<b>TITLE</b> INCREASE ONE/SHOT READ/WRITE MARGINS			PIB NO. DK3037	
PRODUCT LINE:	TAPE DISK FORMATTER <input checked="" type="checkbox"/>	EQUIPMENT CHANGED O/S R/W 103721	MODEL SERIES AFFECTED D3000	EFFECTIVE DATE 5/16/75
<b>CLASS OF BULLETIN:</b> <input checked="" type="checkbox"/> IMPROVEMENT <input type="checkbox"/> RETROFIT ON FAILURE <input type="checkbox"/> RETROFIT RECOMMENDED <input type="checkbox"/> SERVICE INFORMATION ONLY		<b>ORDER PART KIT NO.</b>  N/A	<b>EFFECTIVITY</b> The following One Shot Data Decodes 103721-02A 103721-02B 103721-04A	
<b>PURPOSE:</b> In the event that an abnormal amount of data/clock bit shift be experienced on the I/O interface, intermittent Read Write errors would result. The purpose of this PIB is to minimize the susceptibility of the Read Write PCBA to bit shift. This change will reduce the amount of internal shift in the ONE's and Zero's signals, thereby increasing the R/W margins.

TITLE INCREASE ONE/SHOT READ/WRITE MARGINS

718 NO.  
DK3037

Drawings:

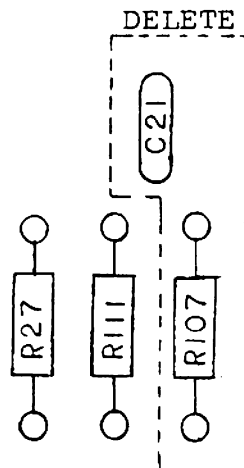
103720  
SHEET 1 ZONE F/7&8

103721  
SHEET 1 ZONE D/7

Sheet 1, note change

13 C3,5,21,24

13 C3,5,24

Sheet 2, TABLE II

change value and part number
